GPU Nuclear Corporation
Post Office Box 388
Route 9 South
Forked River, New Jersey 08731-0388
609 971-4000
Writer's Direct Dial Number:

Subject: Oyster Creek Nuclear Generating Station
Docket No. 50-219
Spent Fuel Pool Expansion - Request for
Additional Information

INSTALLATION OF LIFTING RIG ONTO
A MODULE POSITIONED IN THE POOL

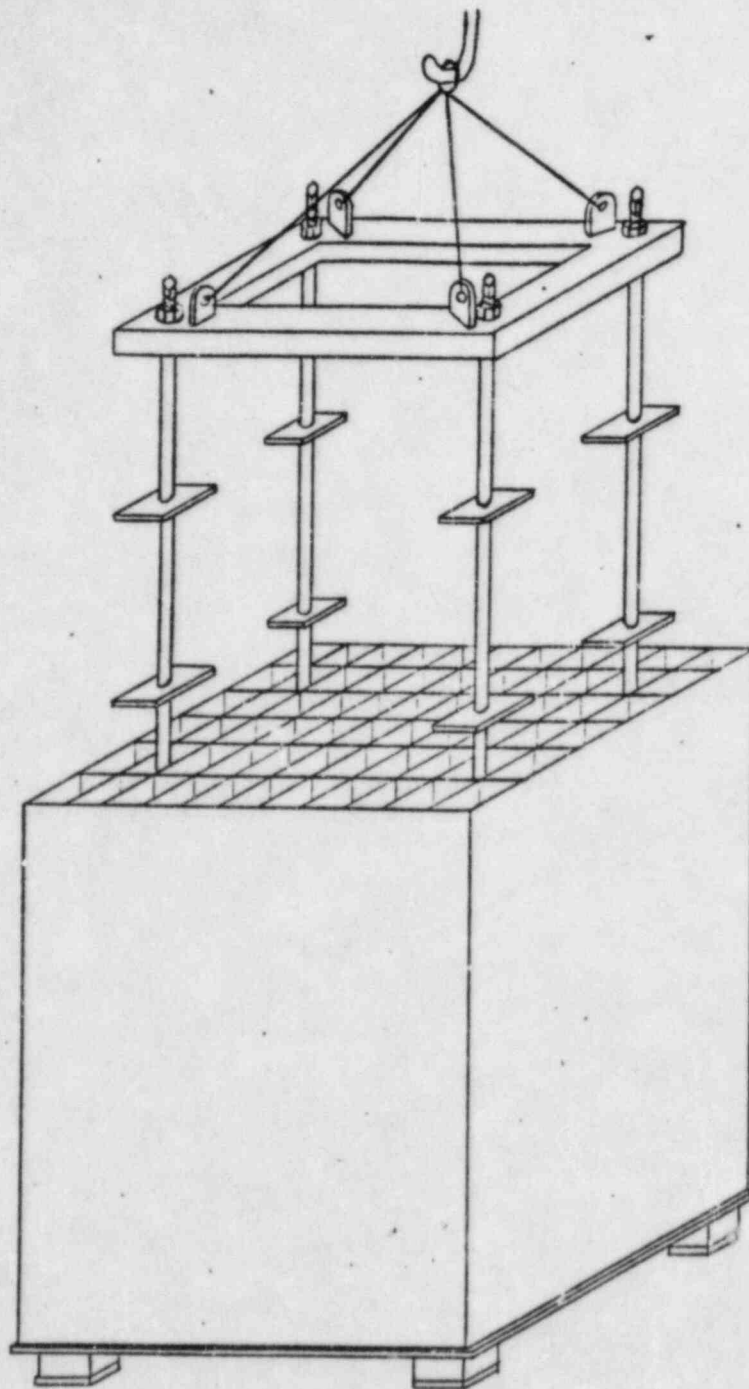
With the aid of drawings, describe and discuss the special lifting devices interposed between the new and old storage racks and the crane hook. Demonstrate that these devices meet the intent of NUREG-0512, Section 5.1.1(4) and (5).

The lifting device used for the new poison fuel racks is shown on the attached Figure 1. The qualifications for this equipment are noted in the response to Question No. 12.

The lifting equipment for the presently installed fuel racks and bases have not been designed yet. However, they will be qualified in accordance with the response to Question No. 12.

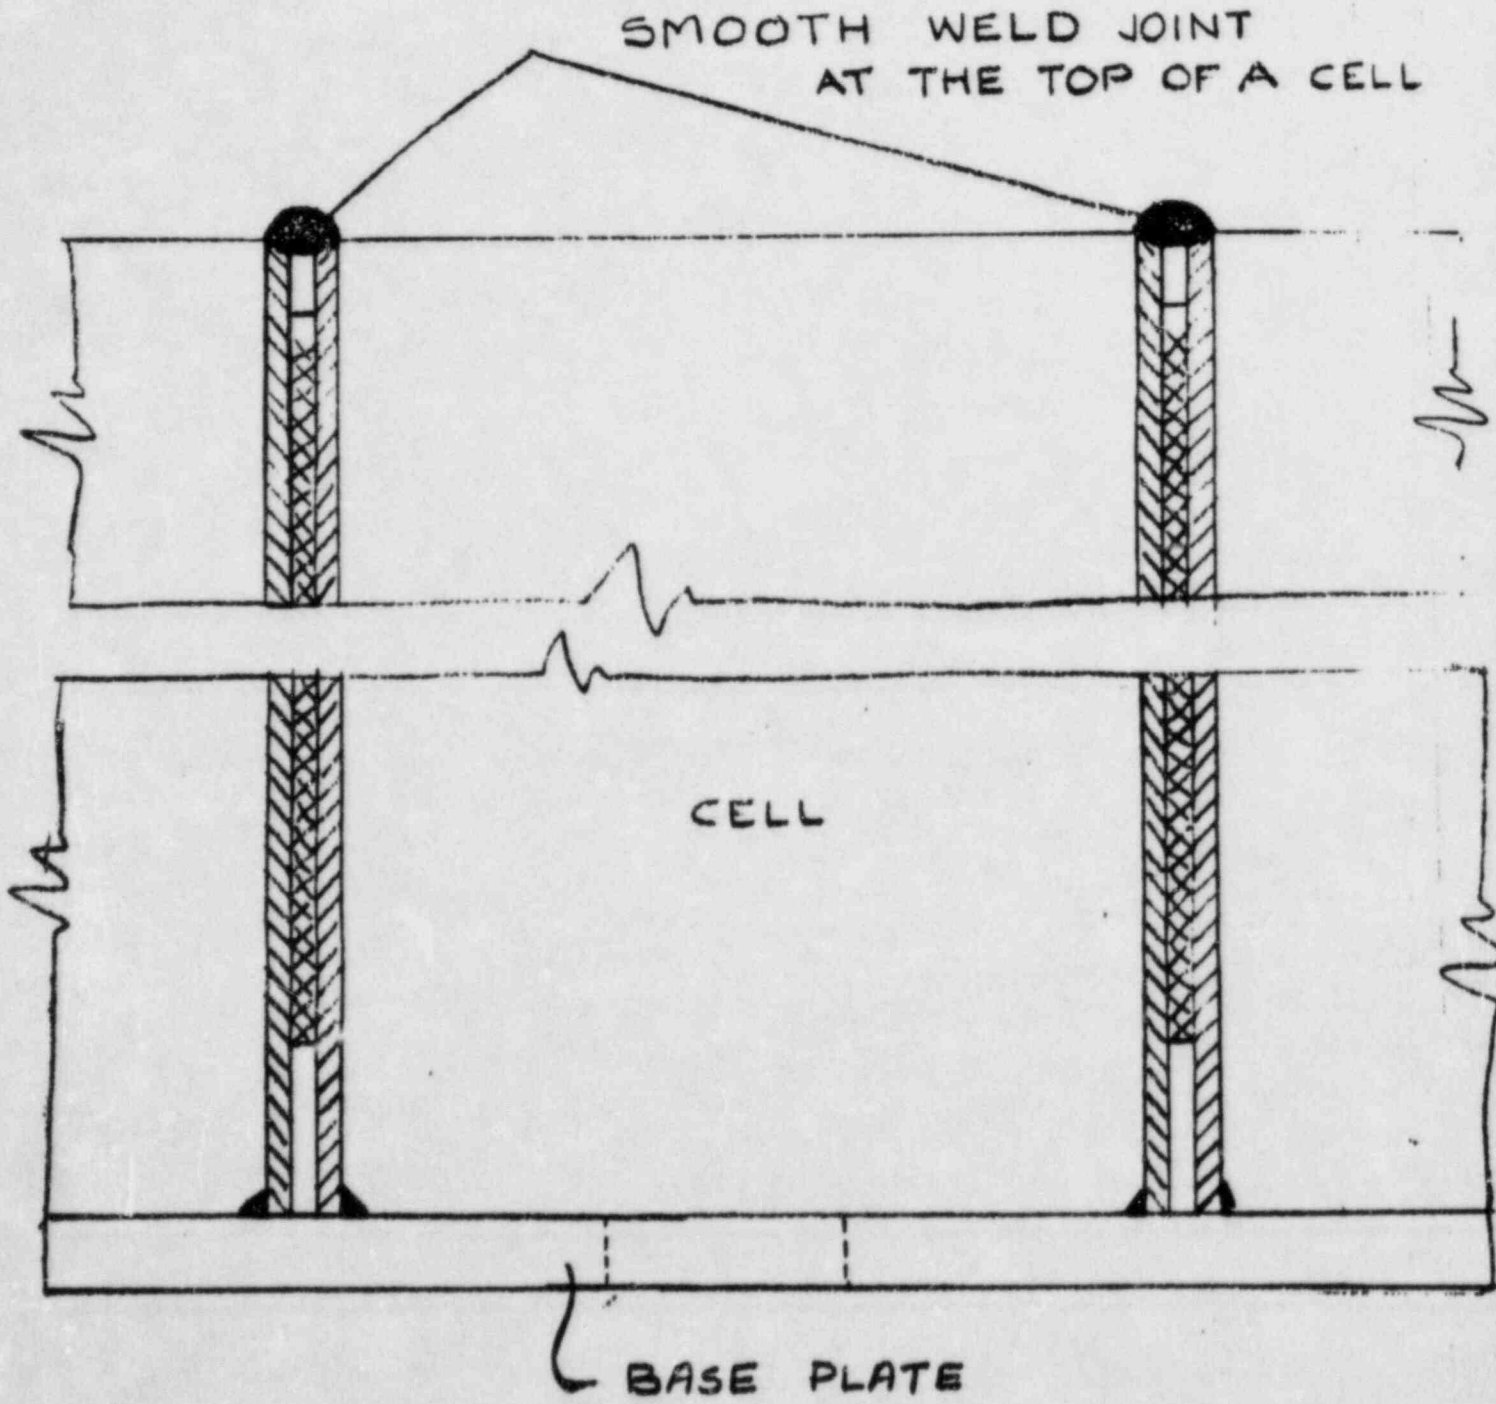
Provide a discussion which demonstrates that a fuel assembly can be safely inserted and withdrawn from the new storage cells that do not have chamfered guides to help align the fuel assembly with the storage cell.

The top of the storage location has a smooth edge cross section as shown in the attached sketch. This geometry provides a smooth insertion contour.
